PLANNING DEPARTMENT STAFF ANALYSIS PLATTING

DATE: January 3, 2018

CASE: S12388

Conservation Subdivision of Lewis and Clark Subdivision, Lots 1 – 16 and Tract A, and a 60-month phasing plan with variances from AMC 21.07.060D.3.b.ii., *Internal Street Connectivity*, and AMC 21.08.030F.6.a., *Cul-de-Sacs*

Map 4.6

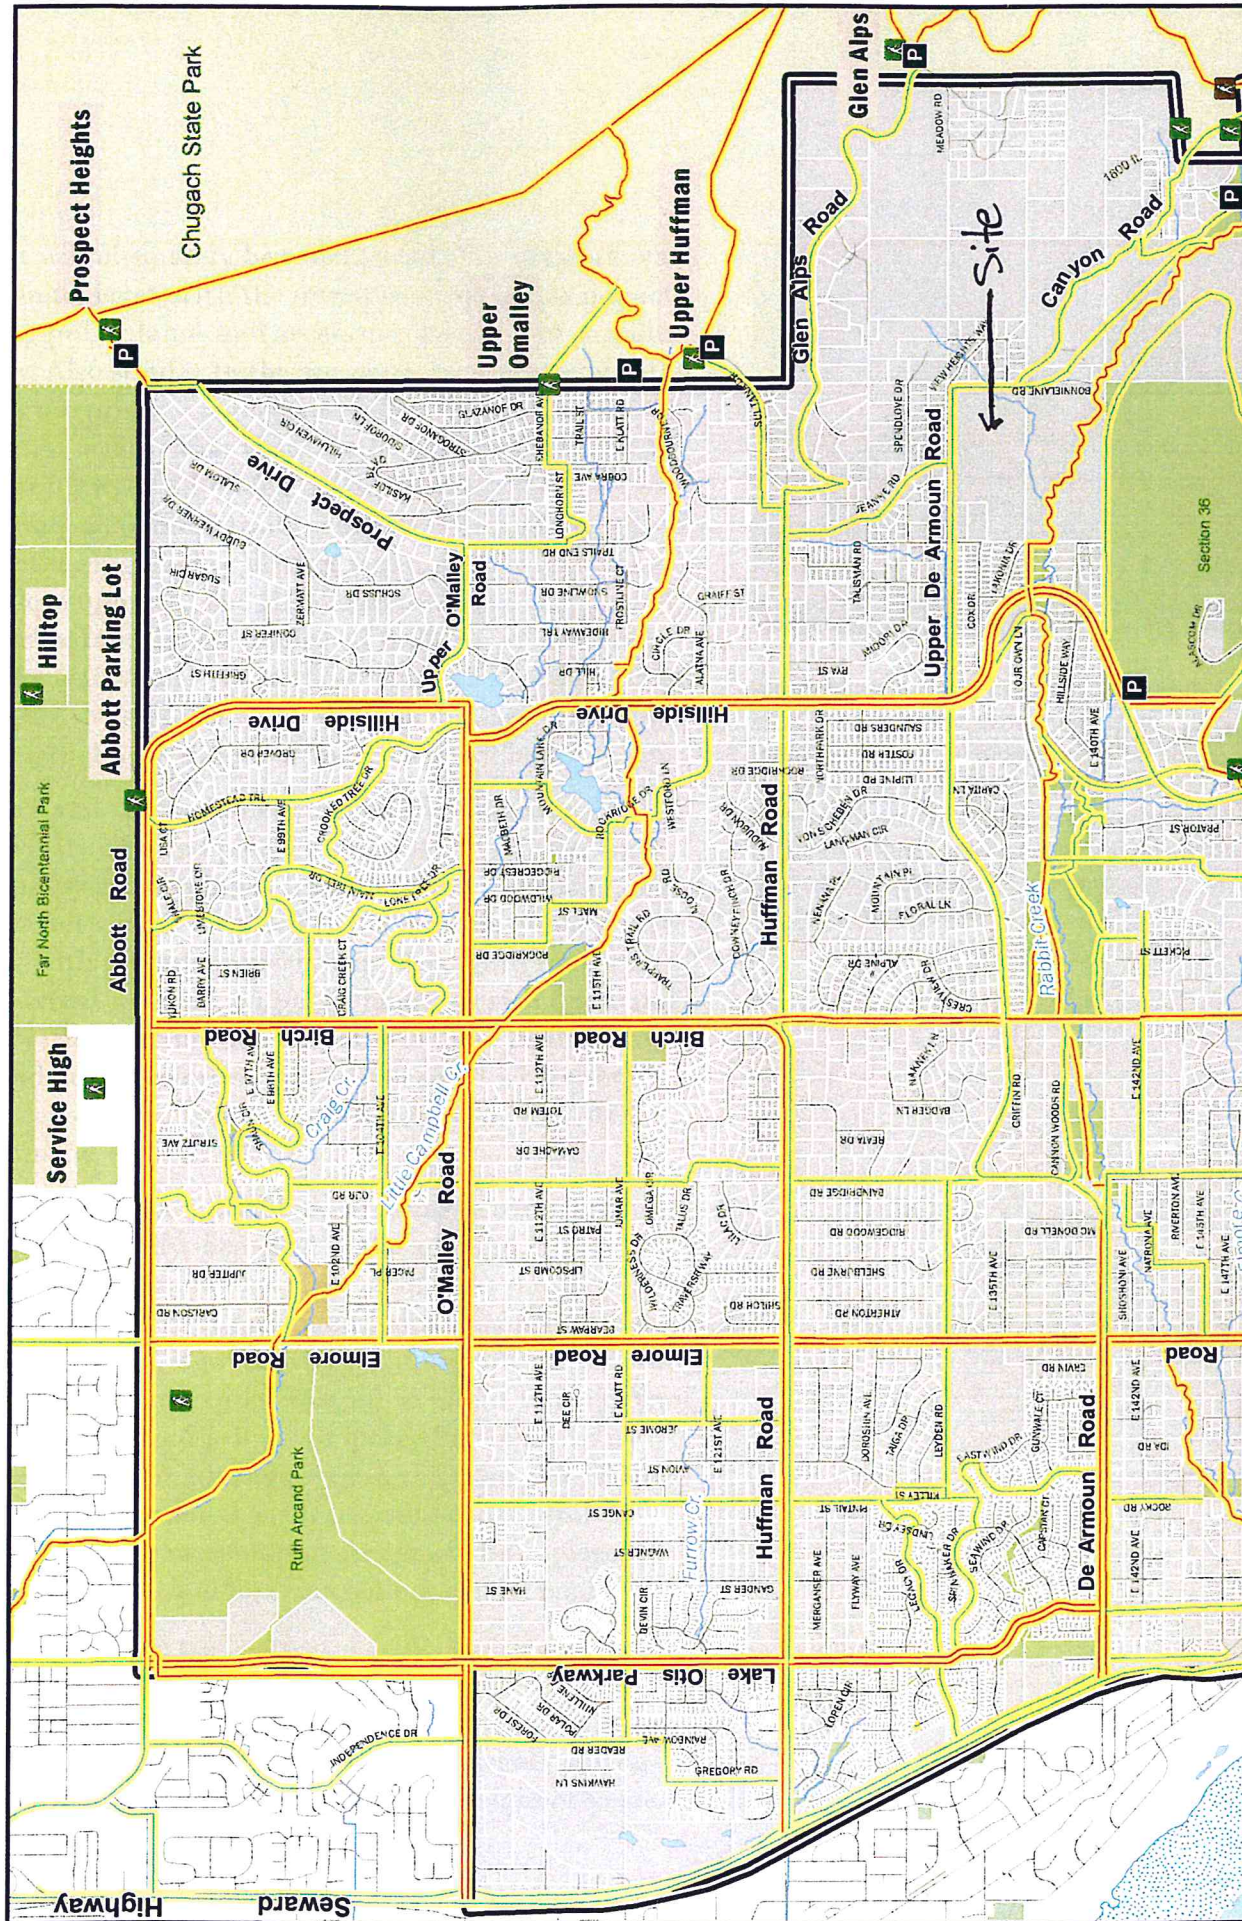
- a. The 2010 Hillside District Plan identifies primary & secondary trail connections along Upper DeArmoun and Canyon Road, bordering this parcel. The proposed plat appears to have provided adequate Right of Way for future development of pathways within these roadways.
- b. Title 21.07.060.D.3.b.ii requires pedestrian easements from cul-de-sacs to the nearest adjacent street. The proposed Brownson Circle's nearest roadway of DeArmoun is an insignificant pedestrian connection only gaining minimal internal street connectivity, however a 10' Walkway Easement is requested within the proposed Lewis & Clark Circle, connecting the cul-de-sac to Canyon Road.

TYPICAL SECTION - 20'/24' STRIP PAVING

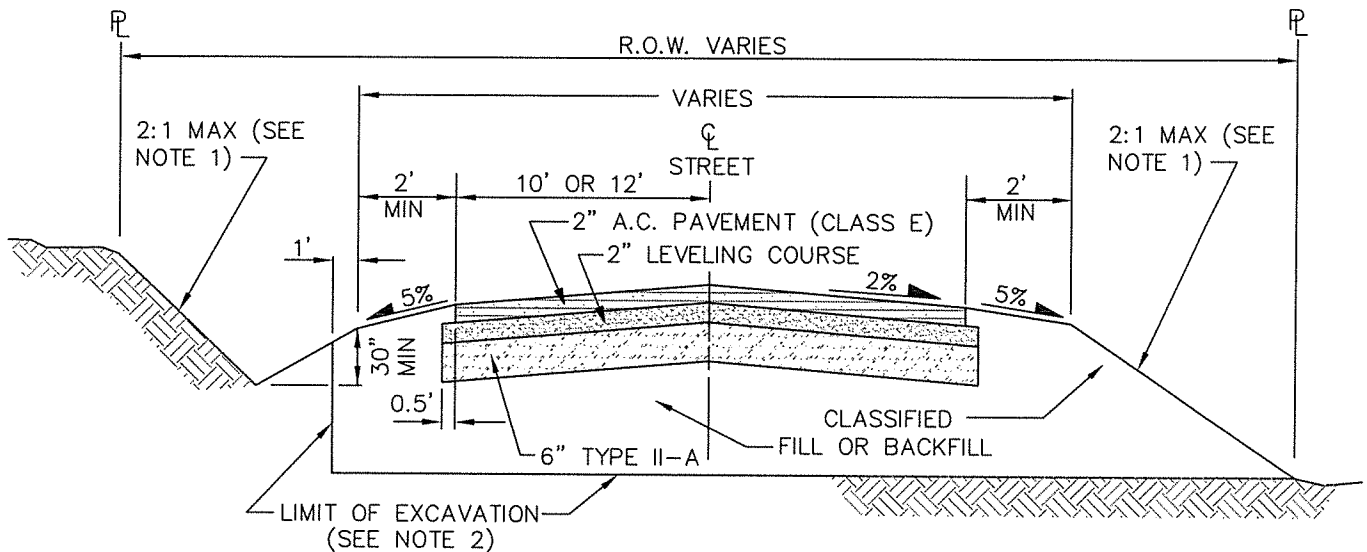
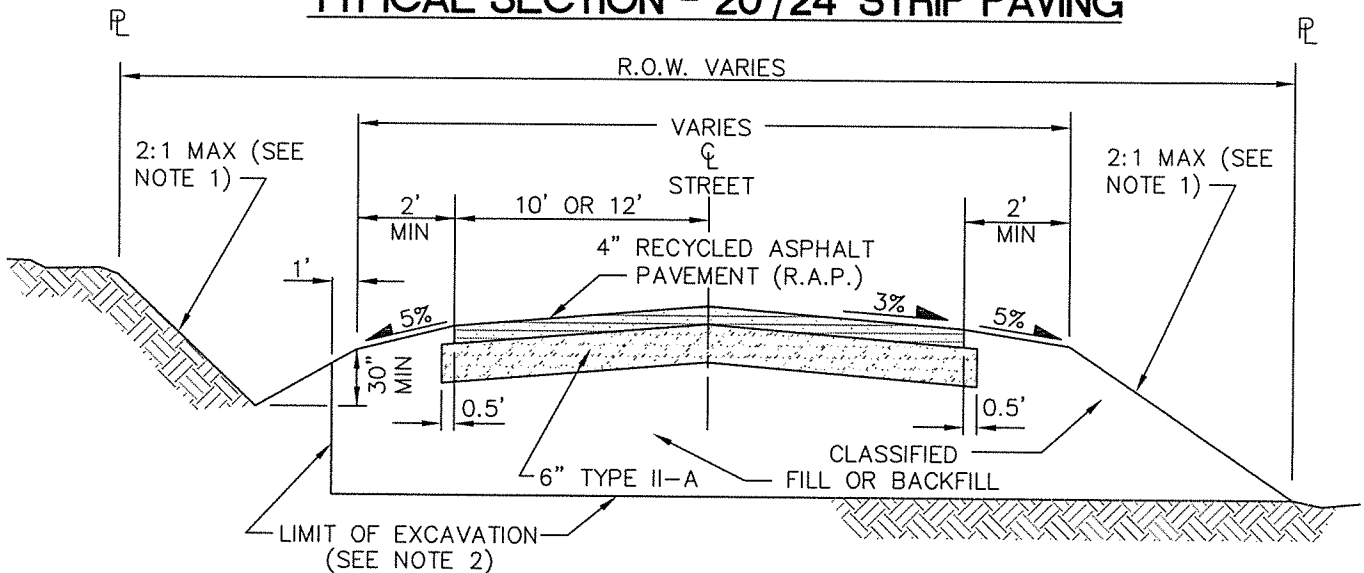
- Lewis & Clark Circle is not constructed where it is internal to the proposed subdivision. The petitioner shall construct to municipal standards a 20-foot wide strip paved street as shown on Typical Section No. 20-1 of the Municipality of Anchorage Standard Specifications.
- Brownson Circle is not constructed where it is internal to the proposed subdivision. The petitioner shall construct to municipal standards a 20-foot wide strip paved street as shown on Typical Section No. 20-1 of the Municipality of Anchorage Standard Specifications.
